ADDENDUM NO. 2 DATE: November 20, 2007

Project: Cypress Point Park – Shoreline Stabilization PW6737
Contract: 7-C-10

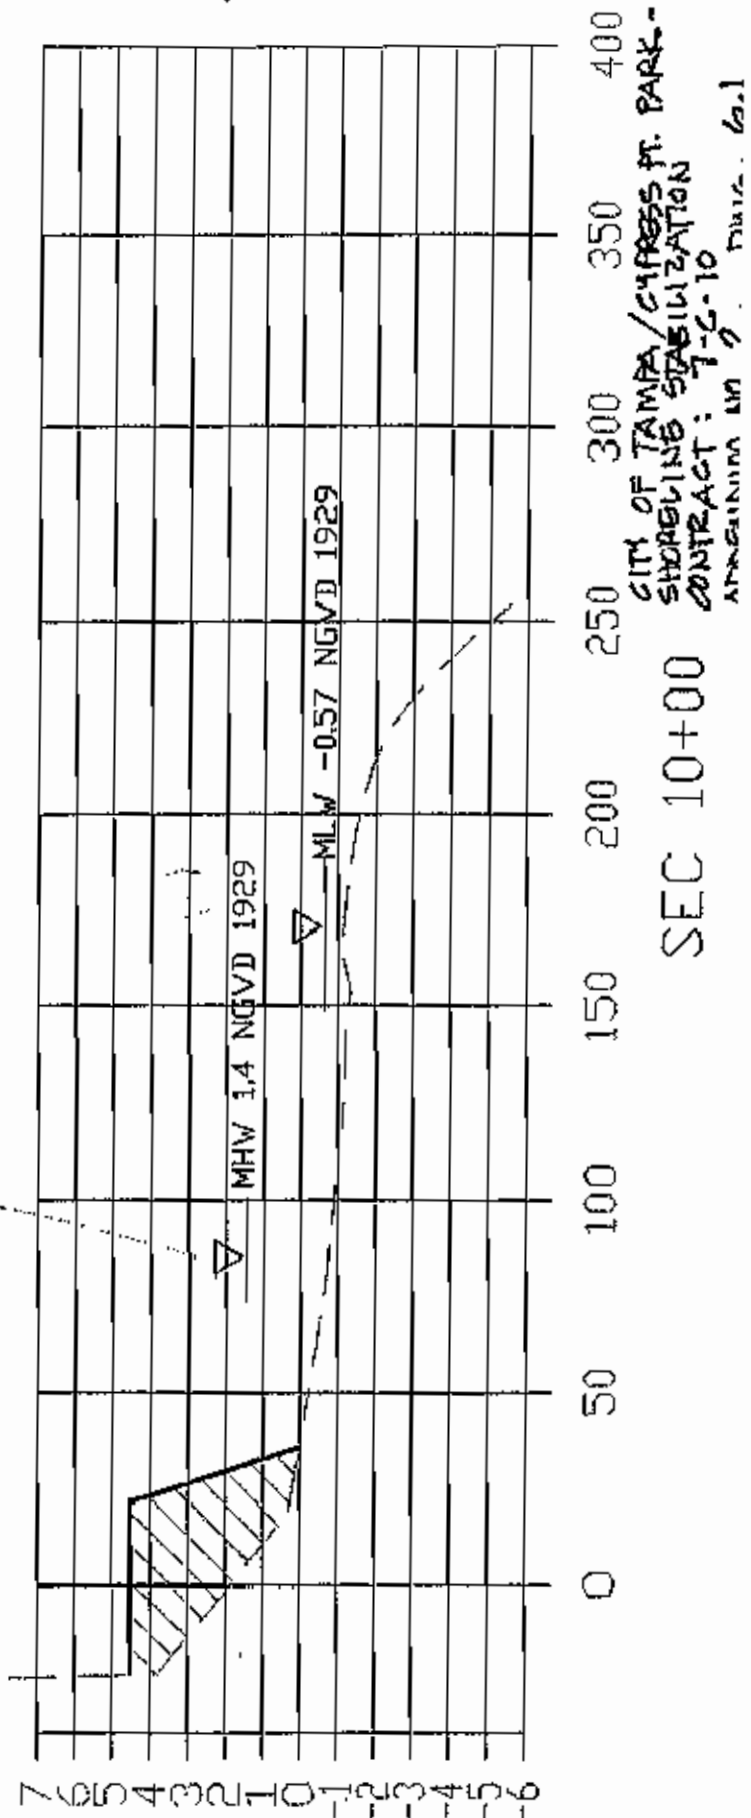
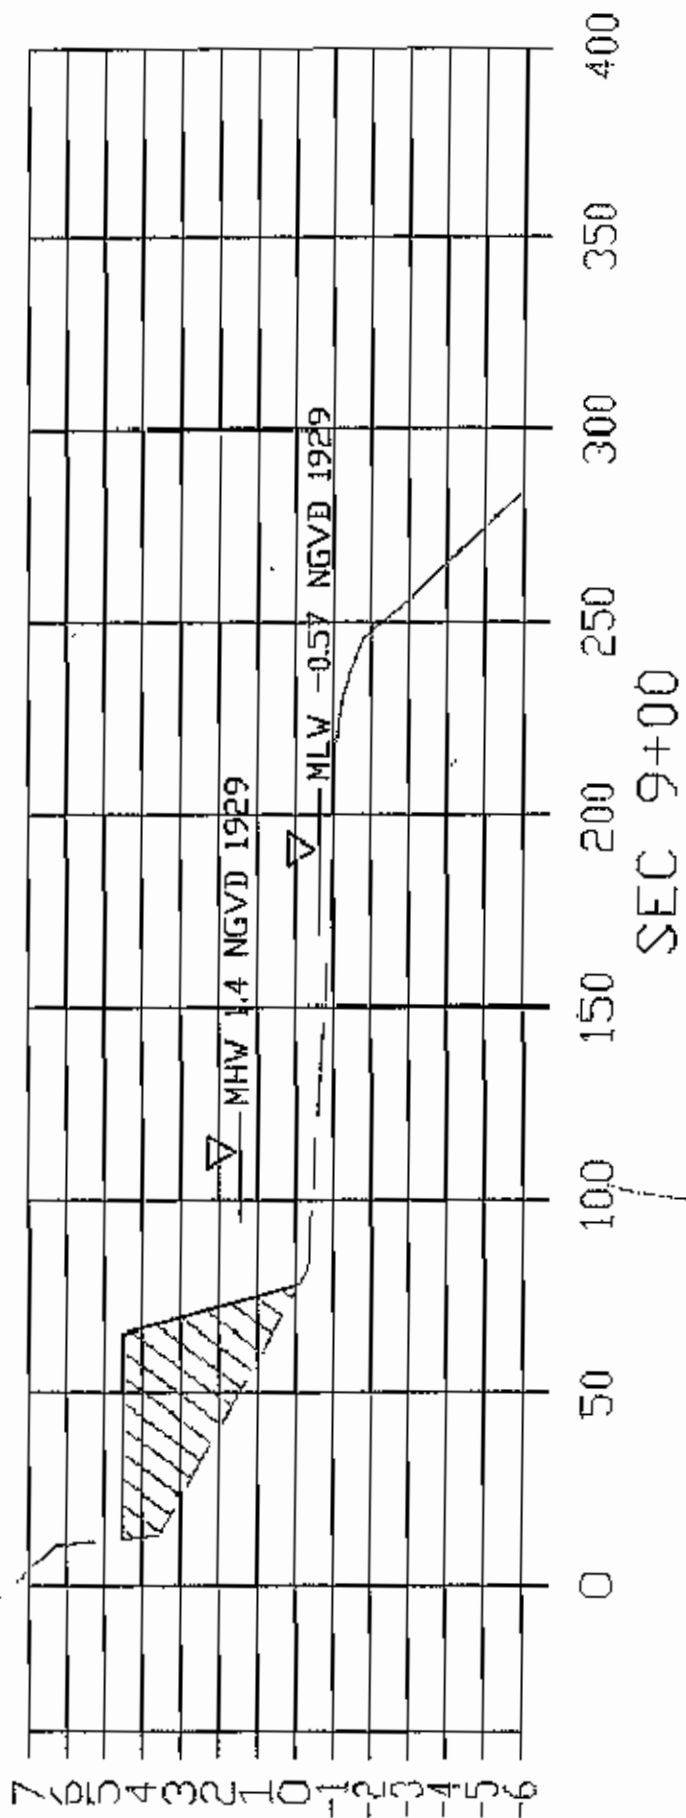
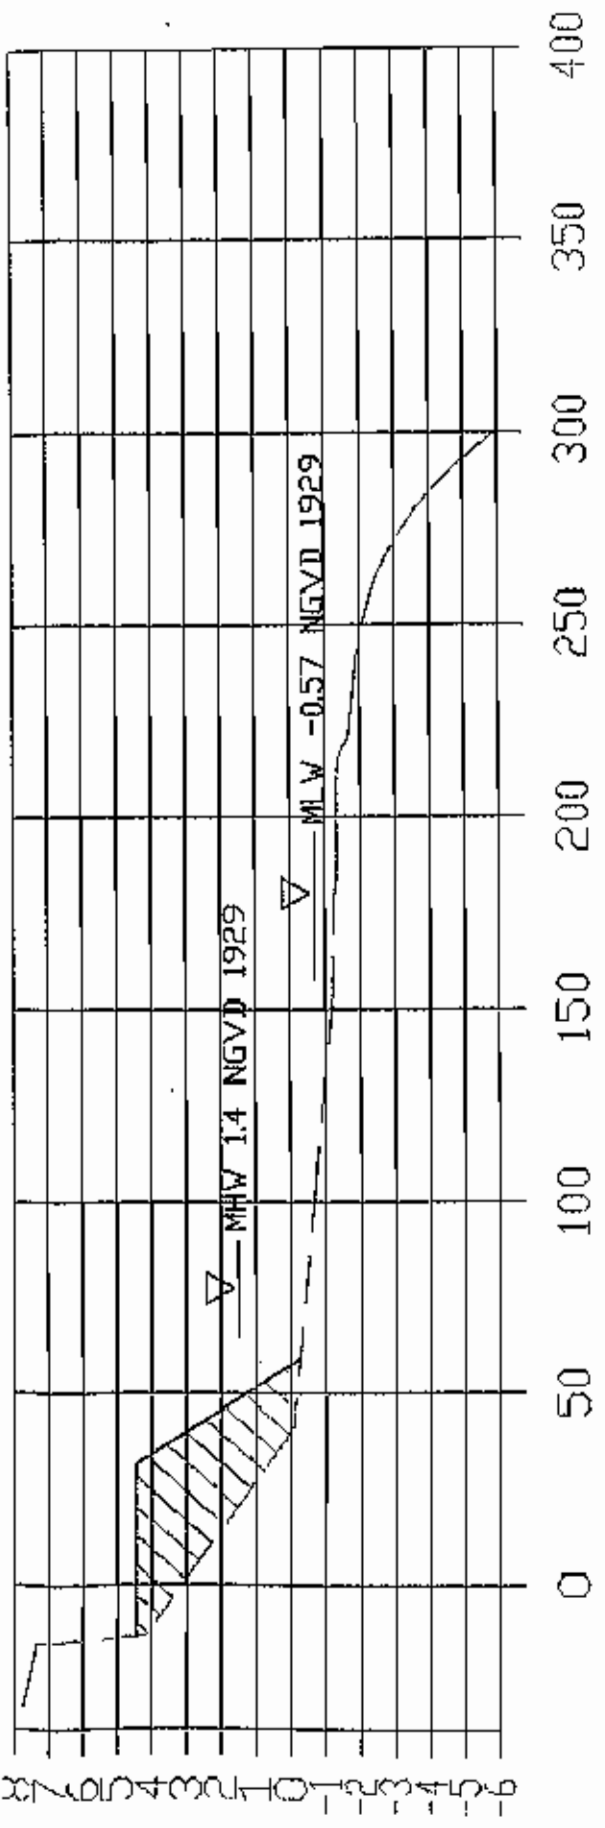
- Item 21: Drawings, Sheet 6 of 7, Section 9+00, Section 11+00 and Section 12+00, utilize Drawing No's, 6.1 and 6.2 attached to this Addendum for scaleable fill profiles for these sections.
